ATTACHMENT I
PROPOSED TECHNICAL SPECIFICATION CHANGES

CONSOLIDATED EDISON COMPANY OF NEW YORK, INC.
INDIAN POINT UNIT NO. 2
DOCKET NO. 50-247
MARCH, 1991

FIGURE 3.1.A-1
PORV OPENING PRESSURE FOR OPERATION LESS THAN OR EQUAL TO 305°F

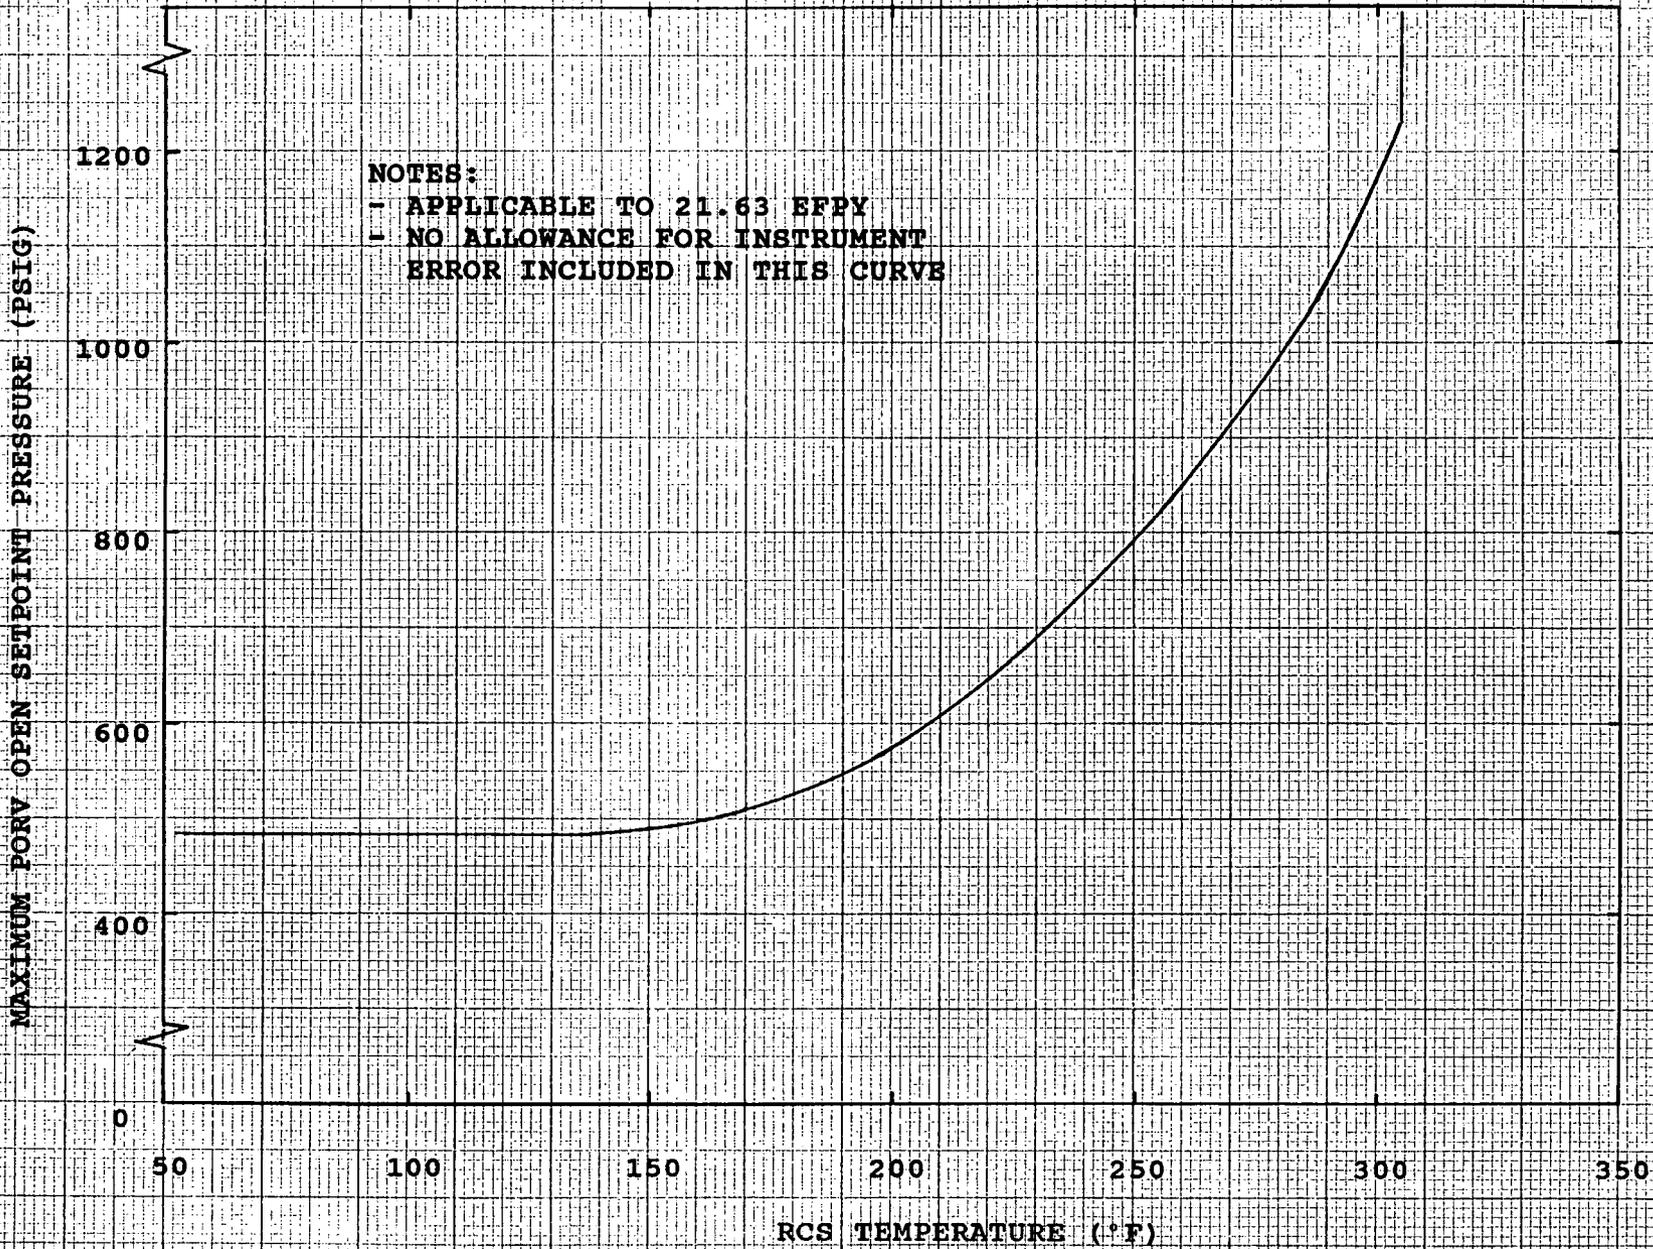
- a. Except as permitted by Table 3.1.A-2, the OPS shall be armed and operable when the RCS temperature is $\leq 305^{\circ}\text{F}$. When OPS is required to be operable, the PORV will have settings within the limits shown in Figure 3.1.A-1.

FIGURE 3.1.B-1
COOLANT SYSTEM HEATUP LIMITATIONS

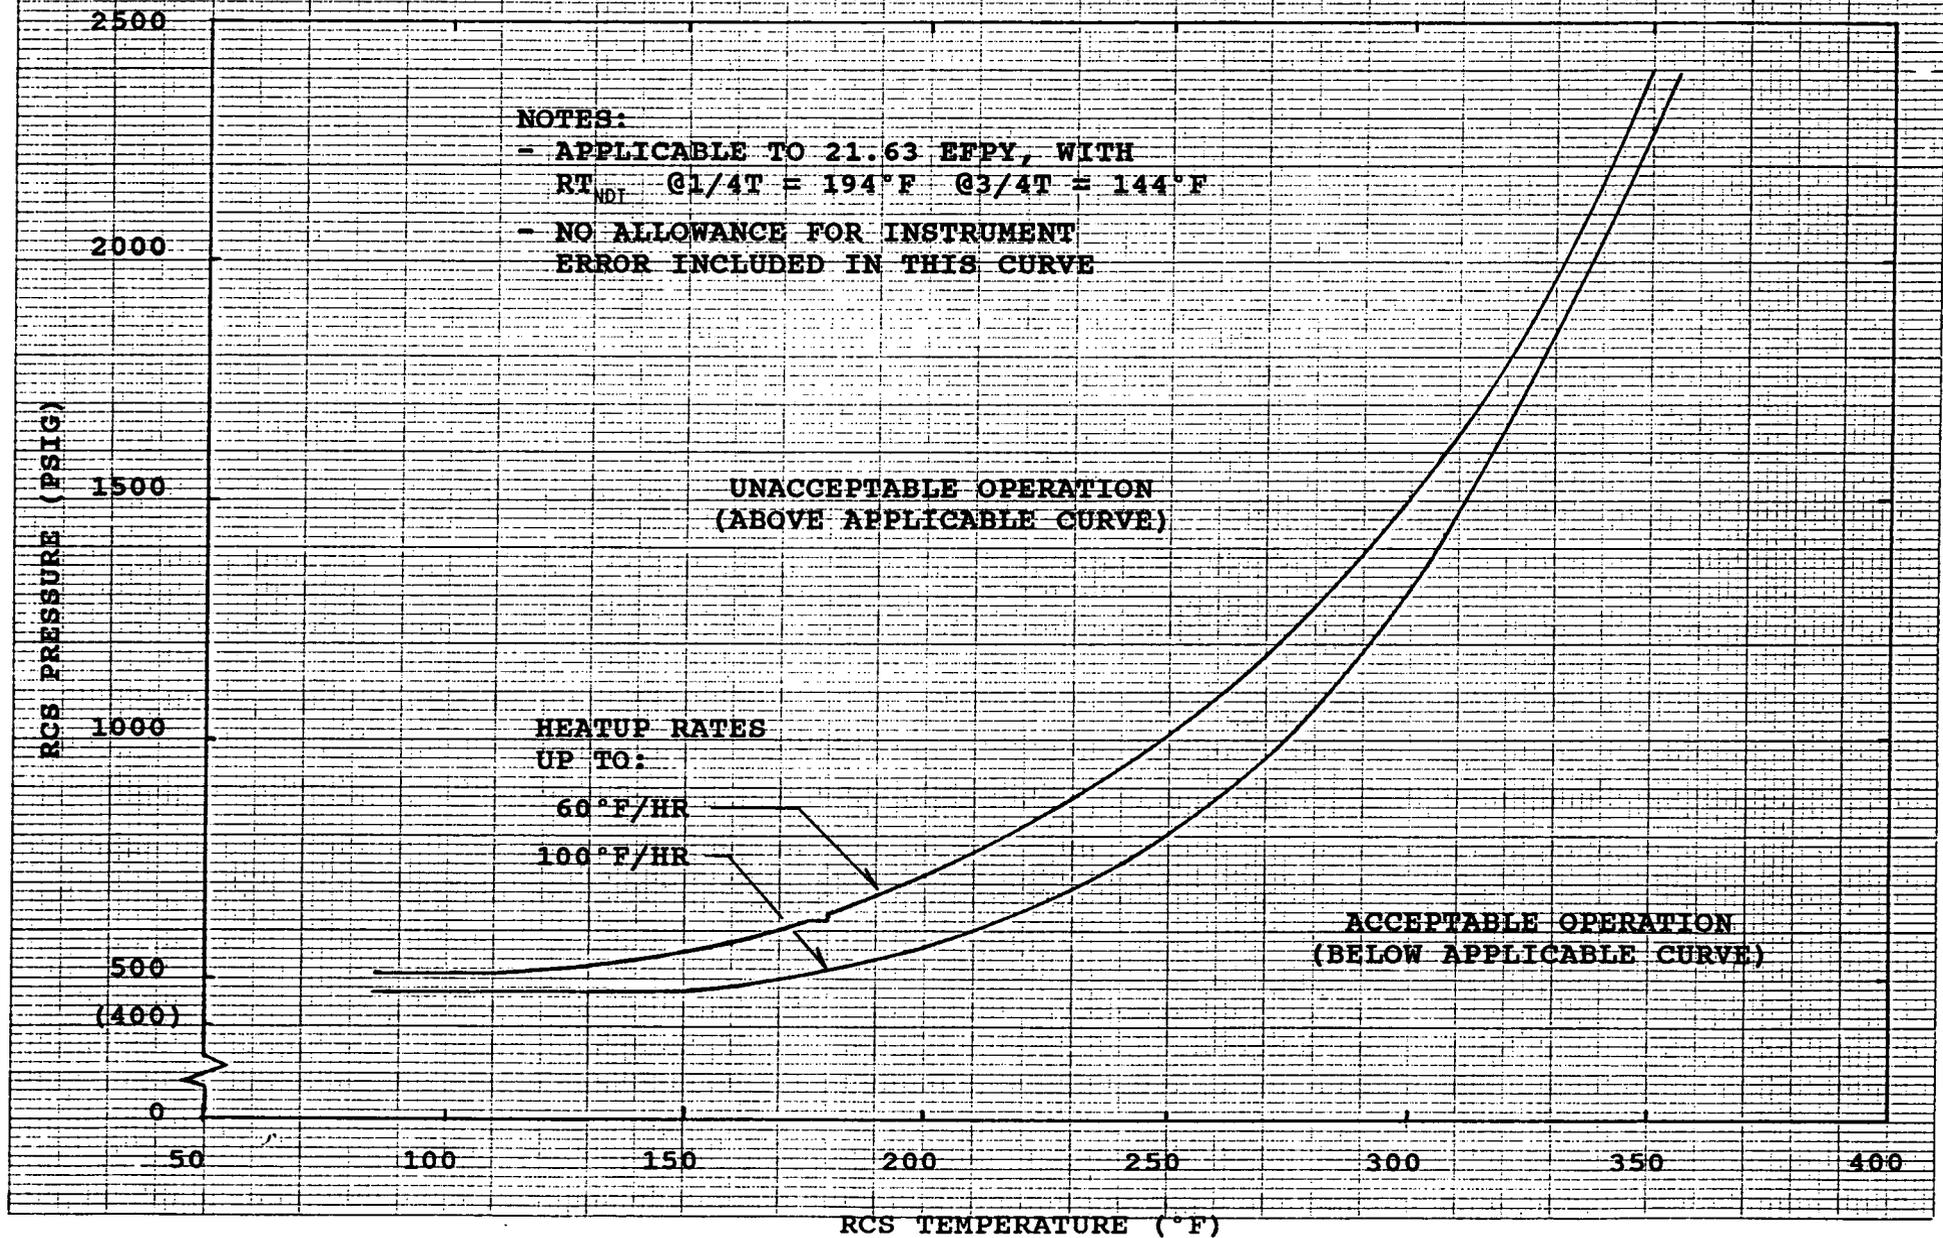
1. The reactor coolant temperature and pressure and system heatup and cooldown rates averaged over one hour (with the exception of the pressurizer) shall be limited in accordance with Figure 3.1.B-1 and Figure 3.1.B-2 for the service period up to 21.63 effective full-power years. The heatup or cooldown rate shall not exceed 100°F/hr.

2. The limit lines shown in Figure 3.1.B-1 and Figure 3.1.B-2 shall be recalculated periodically using methods discussed in WCAP-7924A and WCAP-12796 and results of surveillance specimen testing as covered in WCAP-7323⁽⁷⁾ and as specified in Specification 3.1.B.3 below. The order of specimen removal may be modified based on the results of testing of previously removed specimens. The NRC will be notified in writing as to any deviations from the recommended removal schedule no later than six months prior to scheduled specimen removal.

FIGURE 3.1.B-2
COOLANT SYSTEM COOLDOWN LIMITATIONS

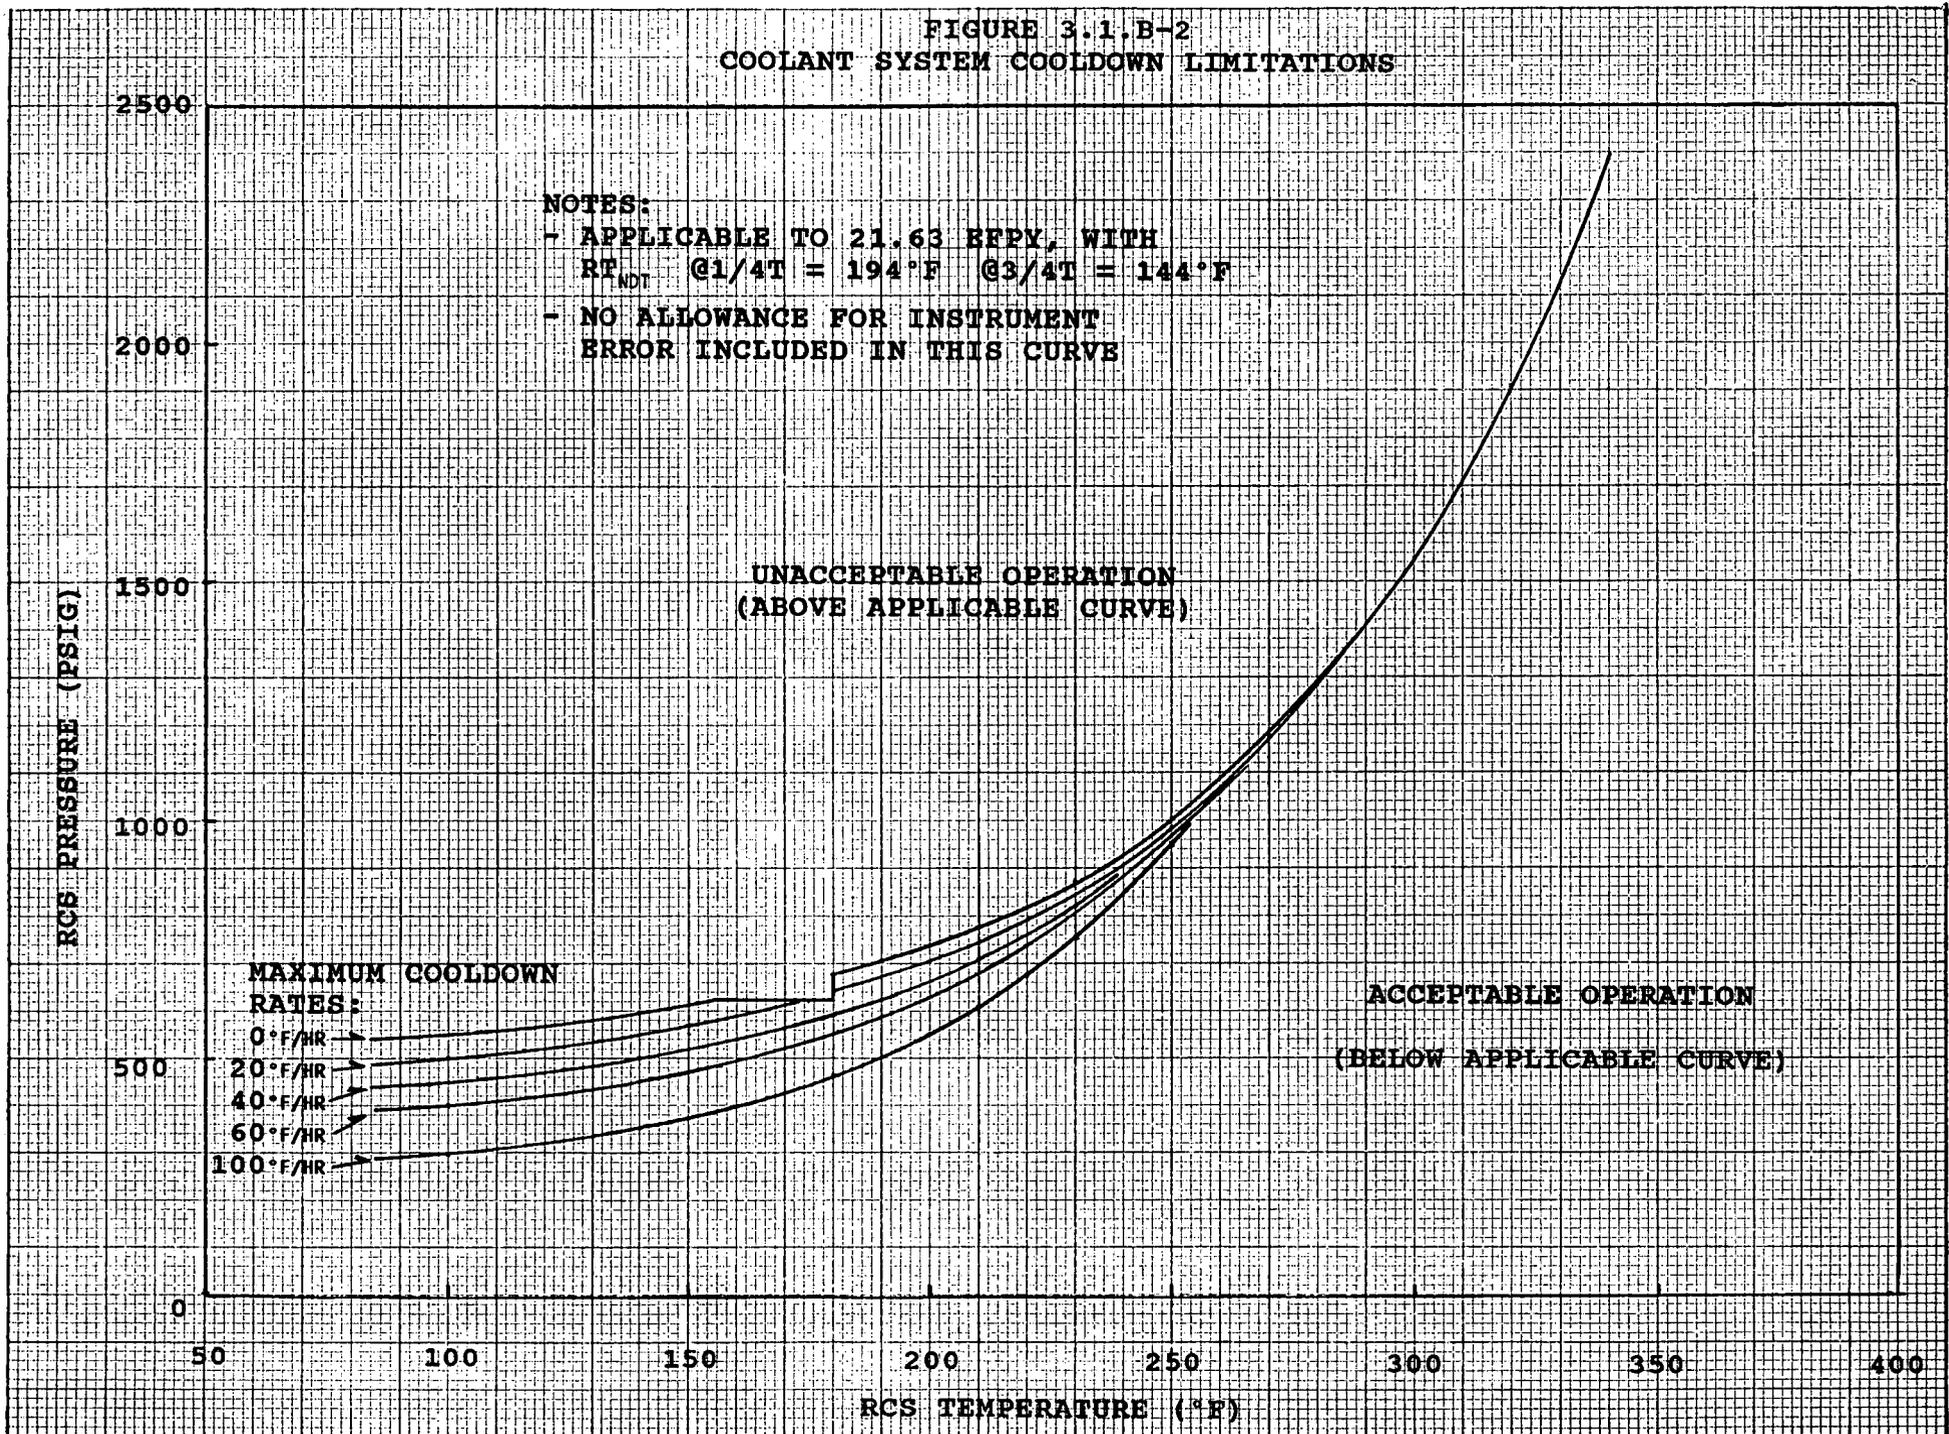
Because operation control is on coolant temperature, and cooldown rate may vary during the cooldown transient, the limit curves shown in Figure 3.1.B-2 represent a composite curve consisting of the more conservative values calculated for steady state and the specific cooling rate shown.

FIGURE 4.3-1
VESSEL LEAK TEST LIMITATIONS

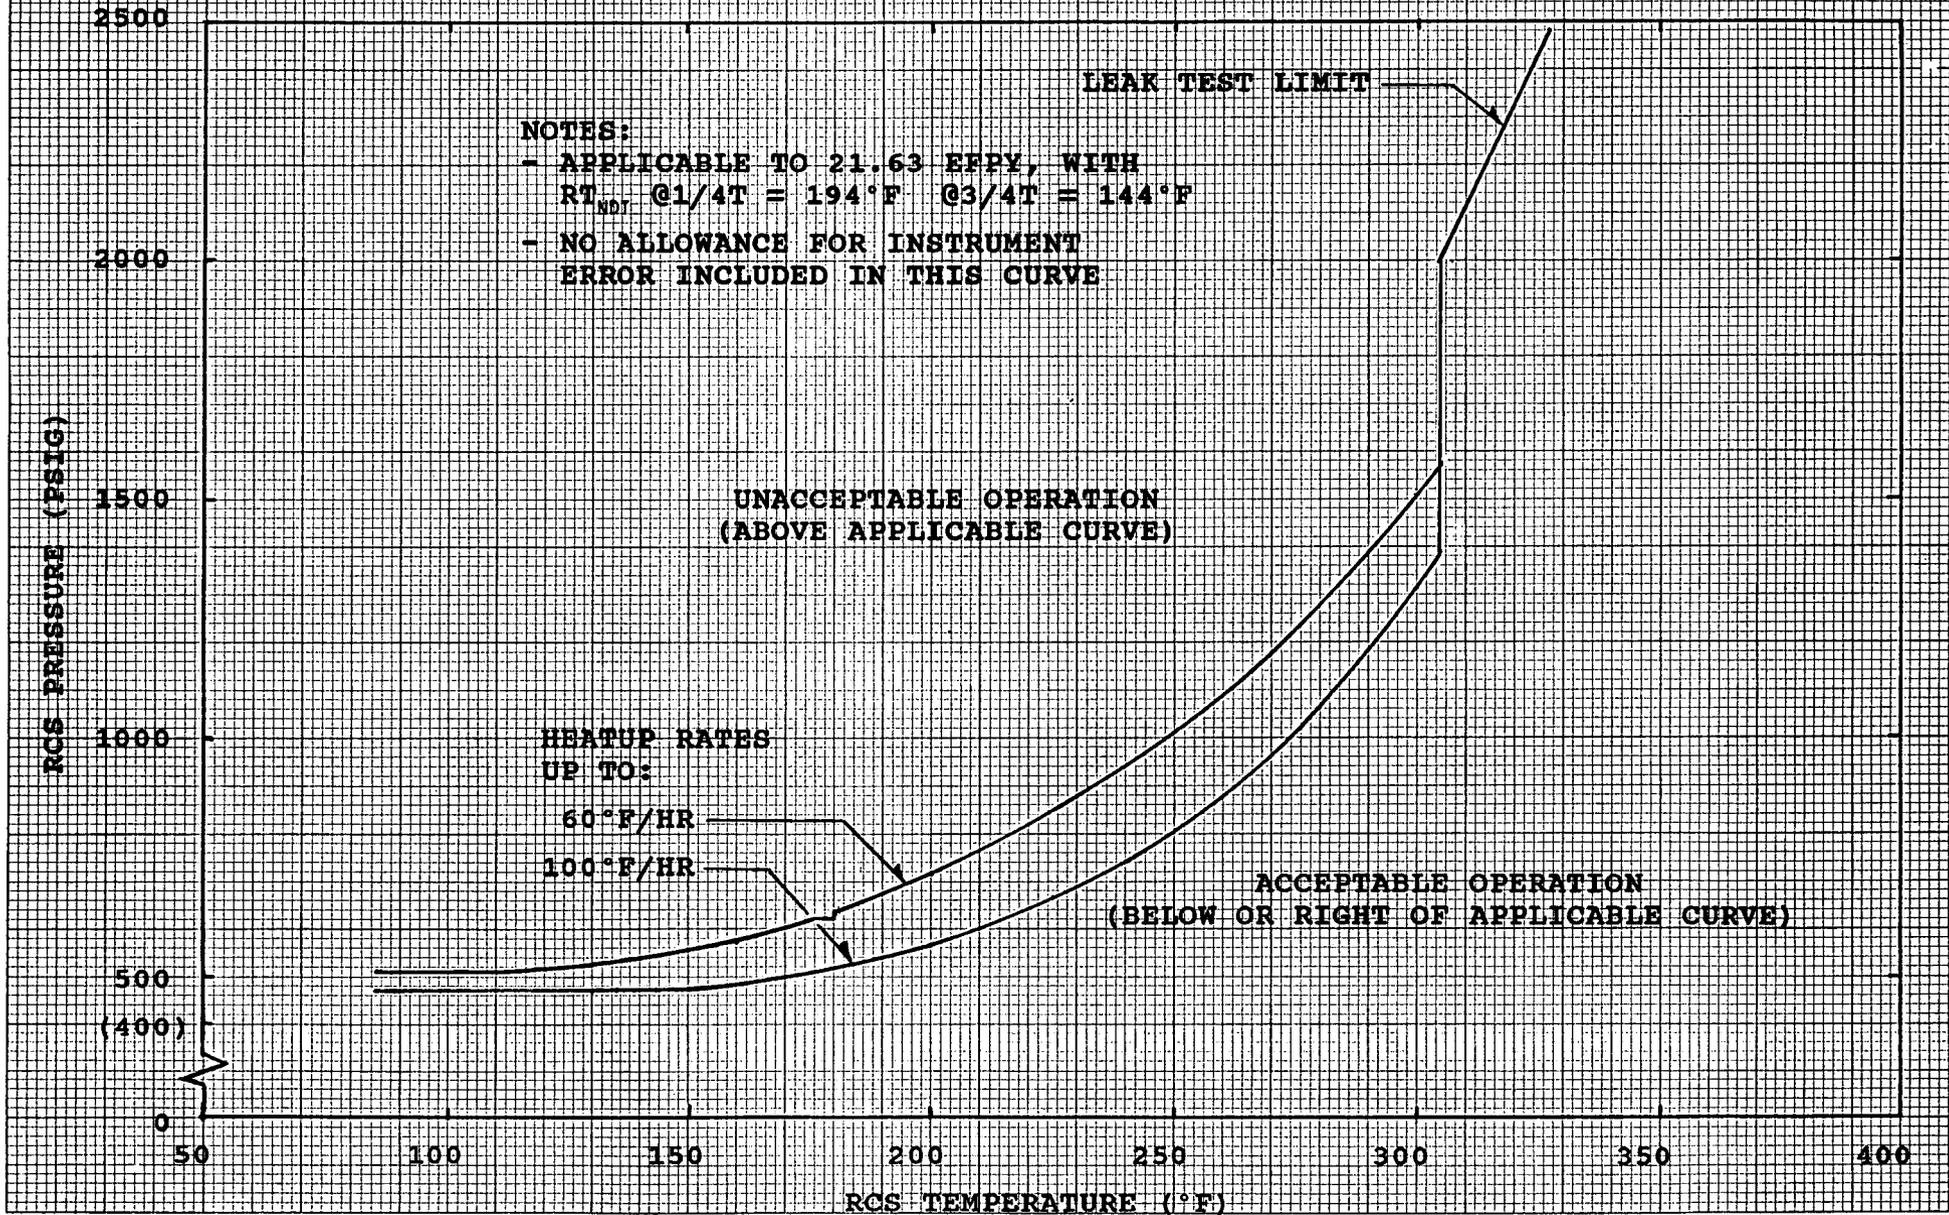
The inservice leak temperatures are shown on Figure 4.3-1. The temperatures are calculated in accordance with ASME Code Section III, 1974 Edition, Appendix G. This code requires that a safety factor of 1.5 times the stress intensity factor caused by pressure be applied to the calculation.

For the first 21.63 effective full-power years, it is predicted that the highest RT_{NDT} in the core region taken at the 1/4 thickness will be 194°F. The minimum inservice leak test temperature requirements for periods up to 21.63 effective full-power years are shown on Figure 4.3-1.

The heatup limits specified on the heatup curve, Figure 4.3-1, must not be exceeded while the reactor coolant is being heated to the inservice leak test temperature. For cooldown from the leak test temperature, the limitations of Figure 3.1.B-2 must not be exceeded. Figures 4.3-1 and 3.1.B-2 are recalculated periodically, using methods discussed in WCAP-7924A and WCAP-12796 and results of surveillance specimen testing, as covered in WCAP-7323.
